Re: Semi-Annual and Annual Report Uranerz Energy Corporation Nichols Ranch ISR Project SUA-1597

**Nichols Ranch ISR Project**  
**License Number SUA-1597**  
**Docket No.40-9067**

**Semi-Annual Report**

INDEX SHEET FOR MINE PERMIT AMENDMENTS OR REVISIONS

## FIGURE 5-1 URANERZ ORGANIZATION

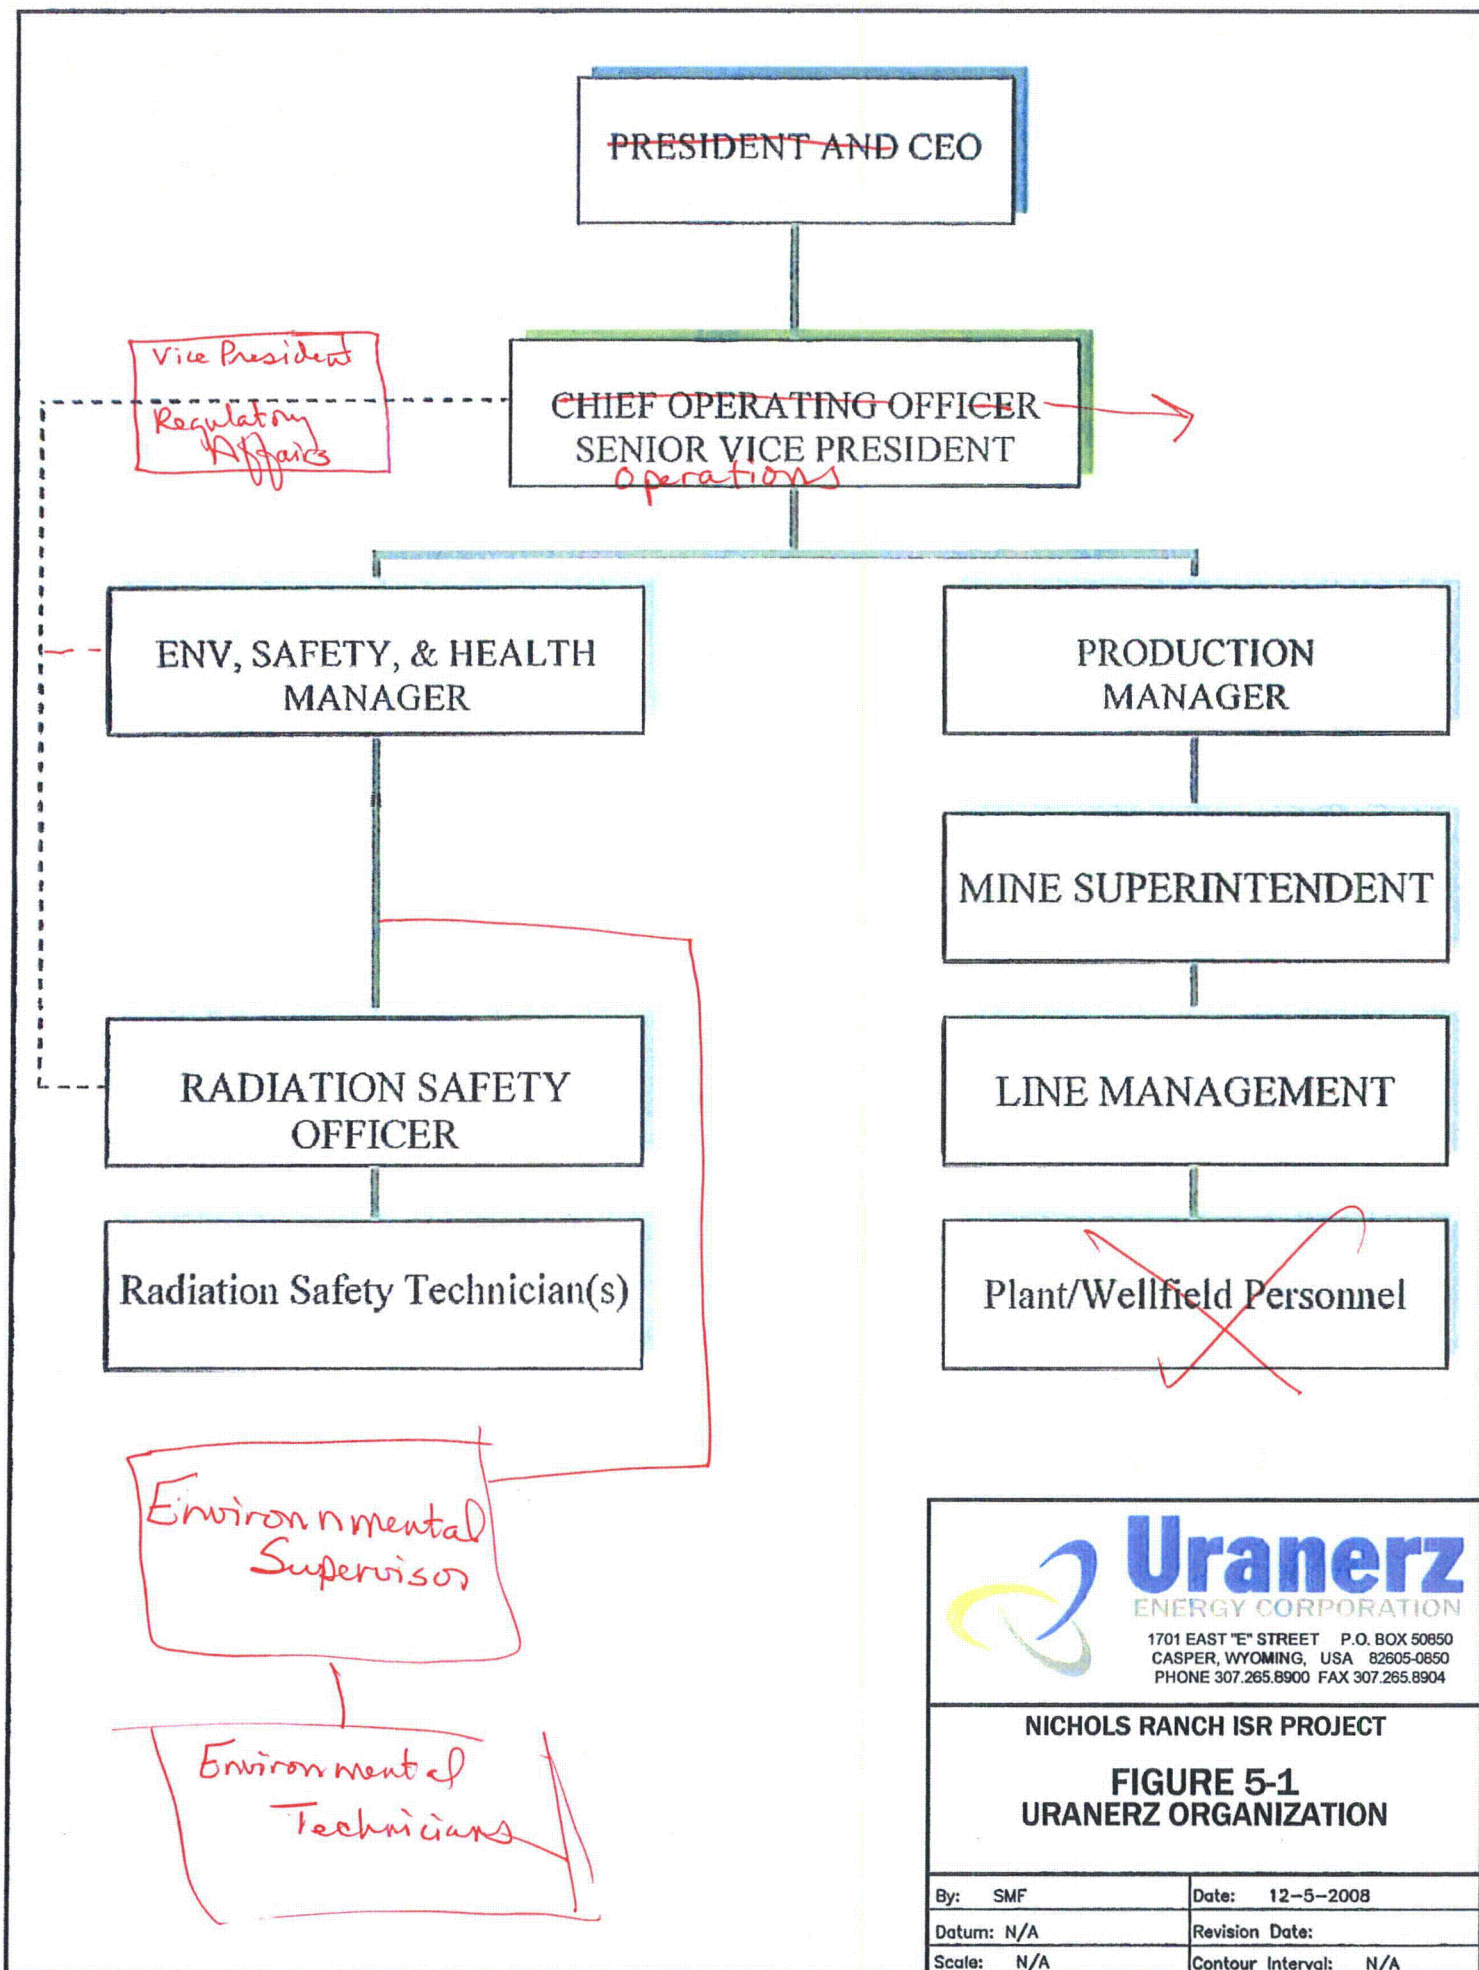
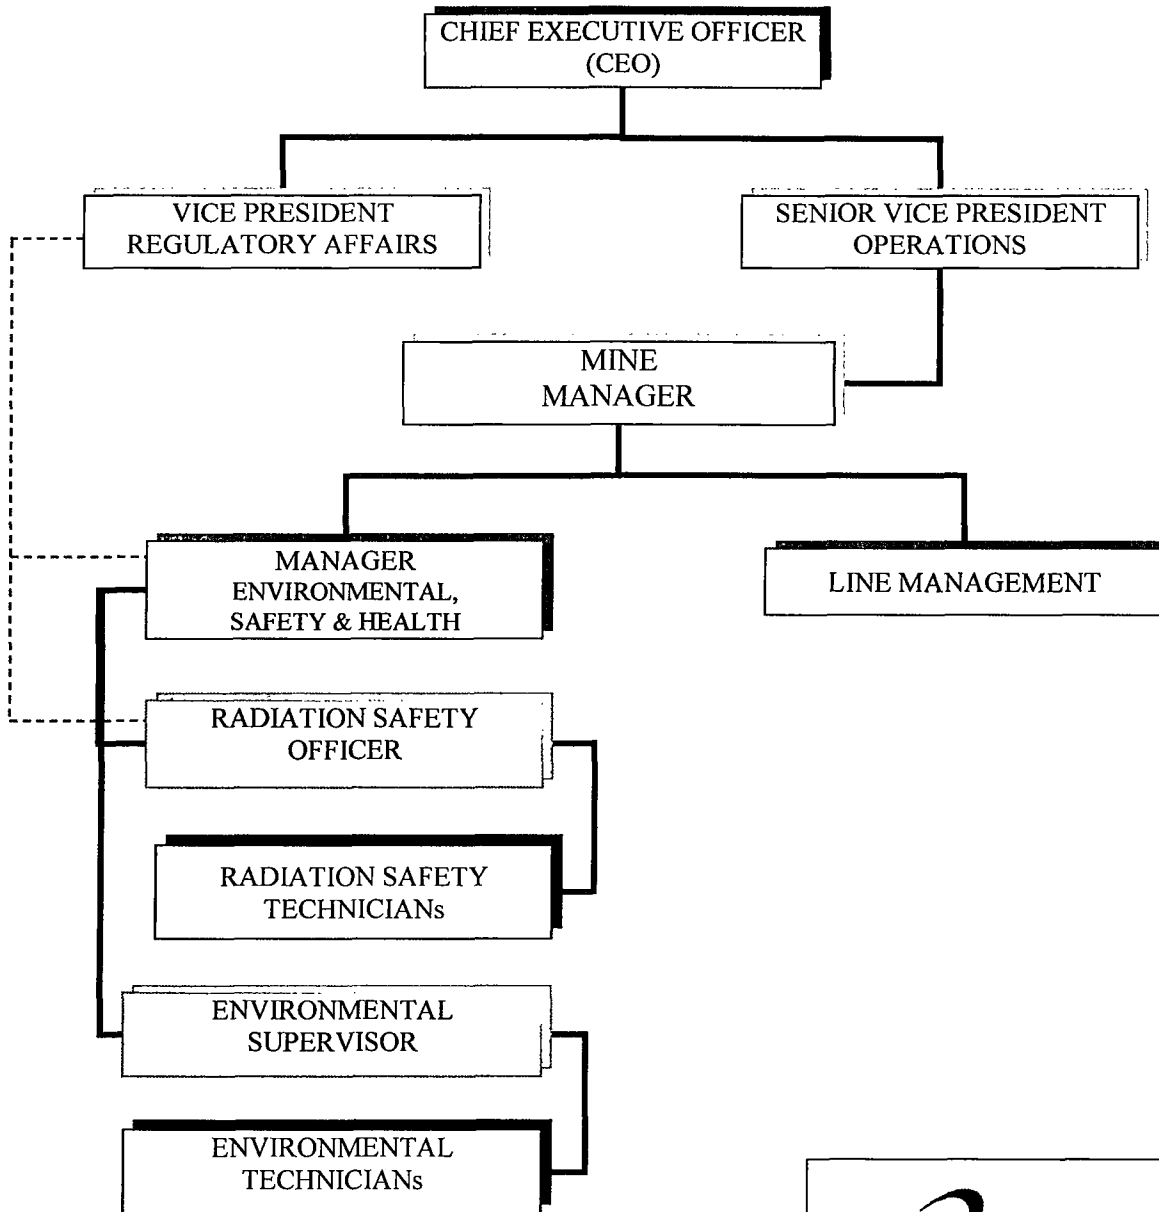
Volume I	Mine Plan Section 3.4.3, Pgs. TR-180 (Revised July 2010)	Mine Plan Section 3.4.3, Pgs. TR-180 and TR-180a (Revised August 2013)	Pages revised for section 3.4.3 Wellfield Injection Patterns to describe organizational structure changes. Figure was revised and is being replaced to illustrate the narrative changes.
Volume I	Mine Plan Section 5.1.1, Pgs. TR-201 (November 2008), TR-202 through TR-206 (Revised July 2012) and Figure 5-1 (12-5-2008)	Mine Plan Section 5.1.1, Pgs. TR-201 through TR-206 and Figure 5-1 (Revised October 2013)	Pages revised for Section 5.1.1 Management, Figure 5-1 revised to reflect narrative changes
Volume I	Mine Plan Section 5.7.8.5.1 Pg. TR-241, Pg. TR-5A-I and Operational Groundwater Sampling Procedure (Revised July 2010)	Mine Plan Section 5.7.8.5.1 Pg. TR-241, Pg. TR-5A-I (Revised December 2013)	Page revised for Section 5.7.8.5.1 Data Collection. The Standard Operating Procedure in Addendum 5A was removed; however a place holder remains for any future needs for an Addendum 5A.

FIGURE 3-13 NICHOLS RANCH & HANK ISR PROJECTS

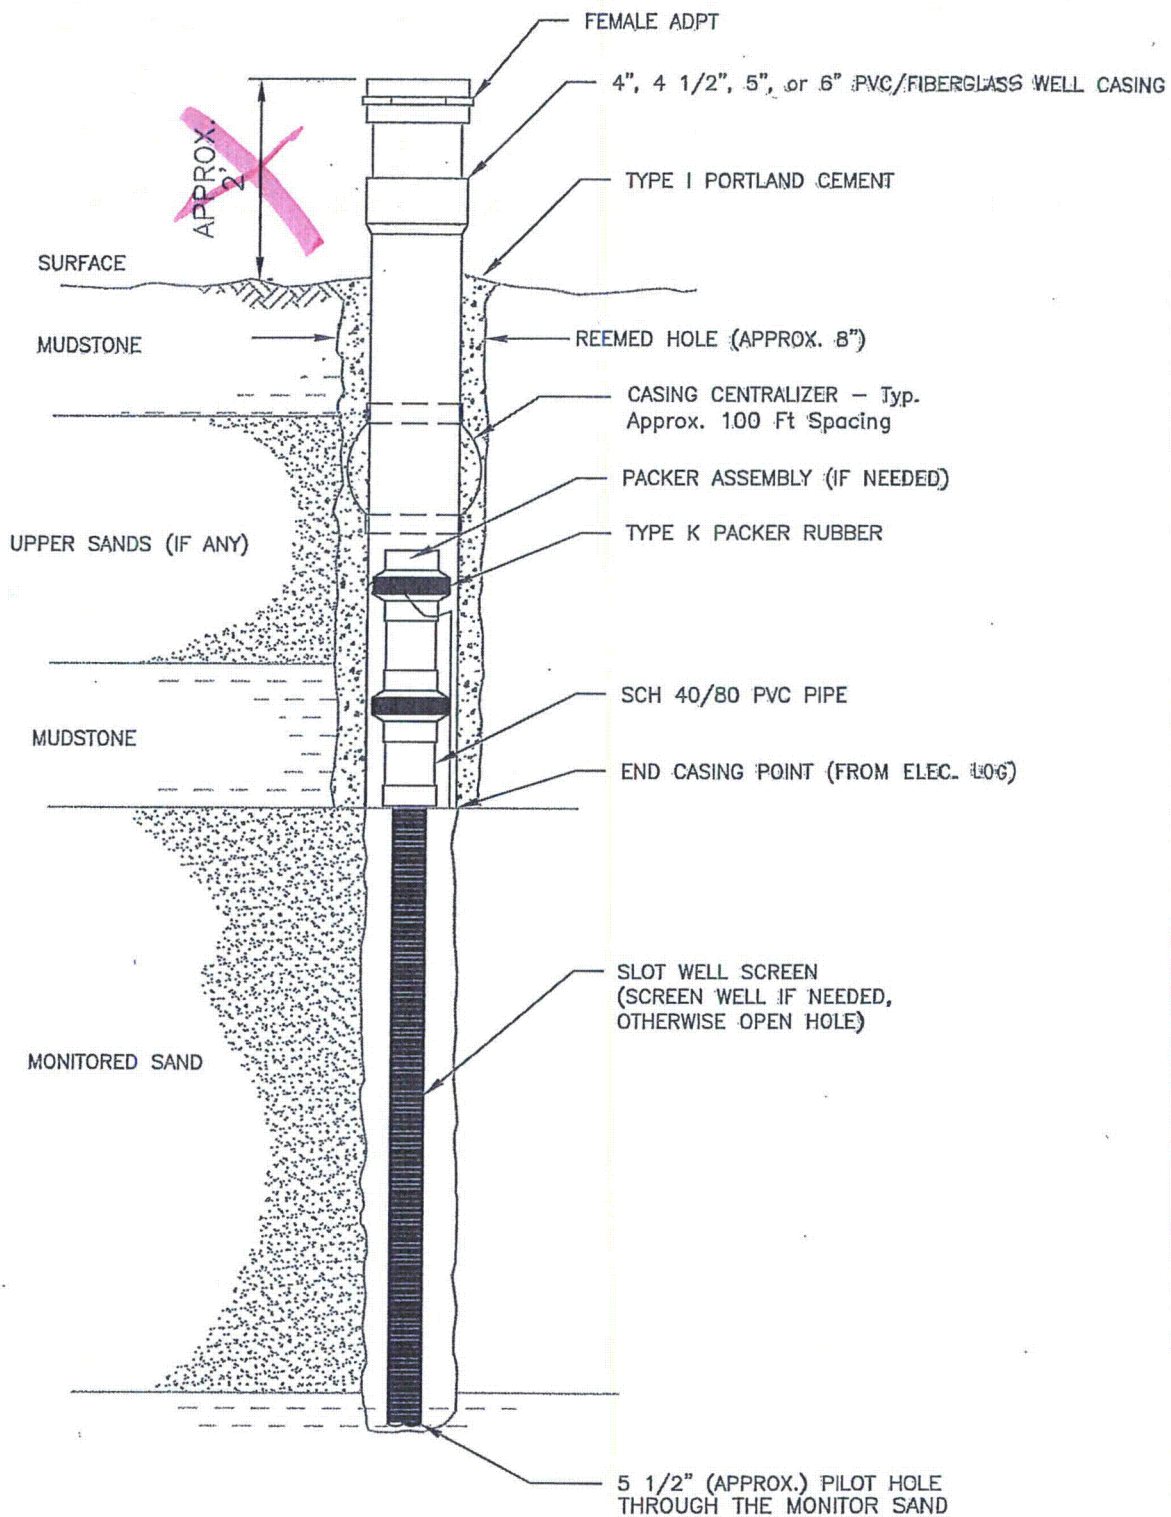
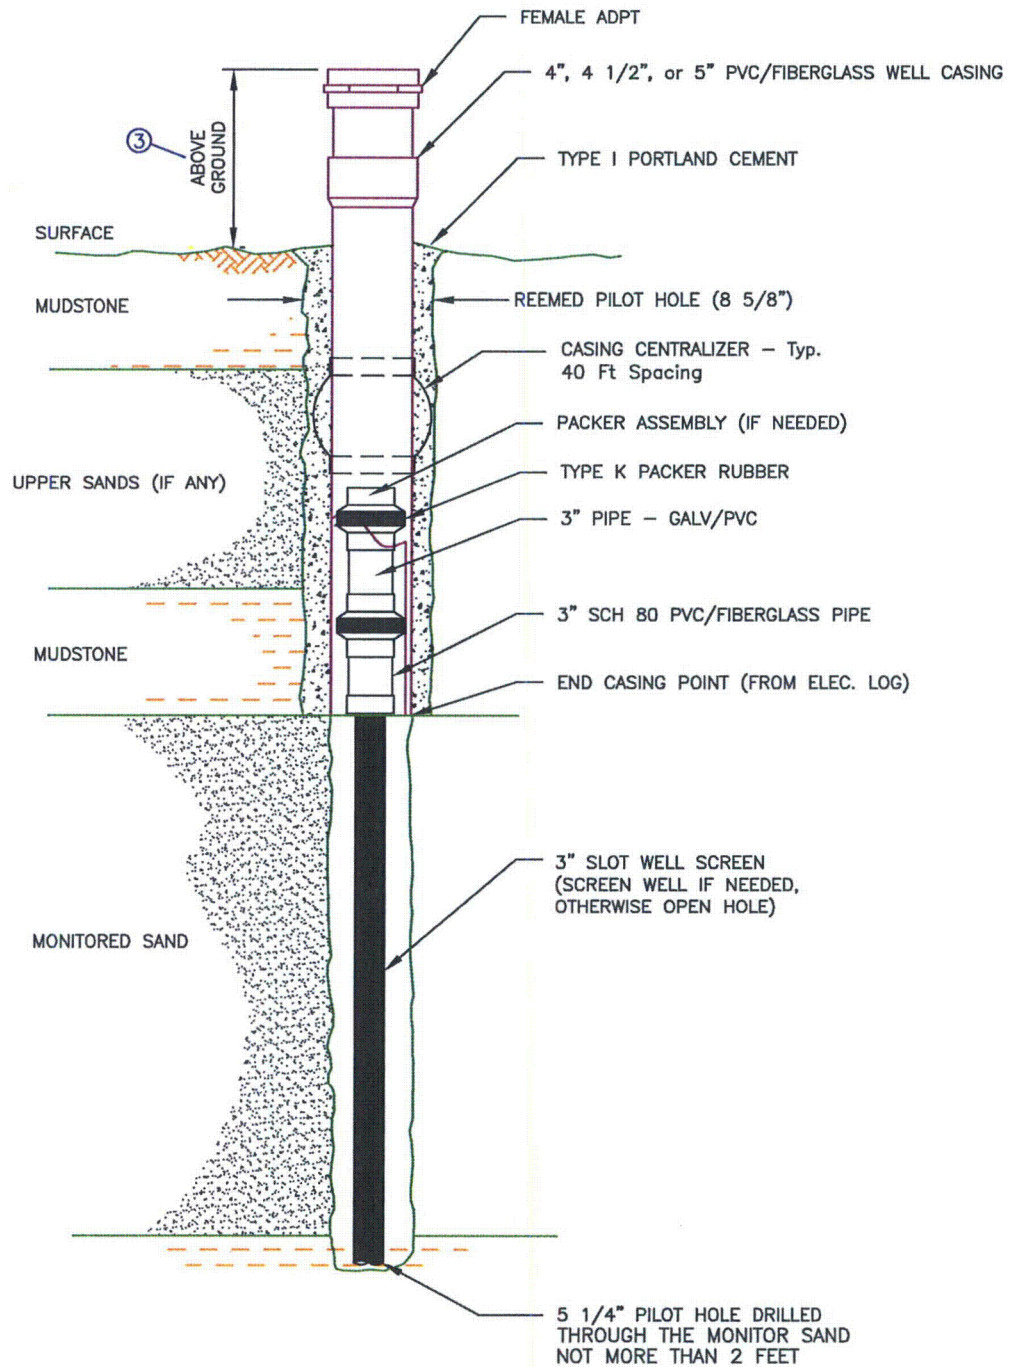
SERP No.	Date	SERP Topic	Evaluation Summary
SERP-4-2013	7/29/2013	Revise Well Diagrams Figures 3-13 and 3-14 in Volume I	Figures 3-13 and 3-14 which are well diagrams, were revised with regard to casing stick up. Well construction is permitted through the WDEQ-LQD regulations which requires that casing sticks up above ground and no height is specified. The intent of well stickup is to prevent entry of foreign materials into the well. These two figures were revised in the DEQ permit and to maintain consistency and therefore compliance the NRC figures were revised. The SERP agreed and concluded that the minor revision to the figures would not change the license application as evaluated as the revisions were in alignment with regulatory requirements.
SERP-5-2013	8/27/2013	11e2 Disposal Site & Methods	The SERP evaluated proposed changes to Section 3.2.6 of Volume I of the license application. The proposal was to change how 11e(2) byproduct material was stored and packaged at Nichols Ranch in order to economically and safely dispose of the material. The changes allow for the use of super sack and lined containers as well as the use of both concrete and or gravel pads in the 11 e 2 disposal areas. The SERP concluded that the changes will not result in increased safety or radiological hazards and will ultimately result in less byproduct material which is in agreement with the ALARA principle. Based on the conclusions the SERP agreed to accept the changes.
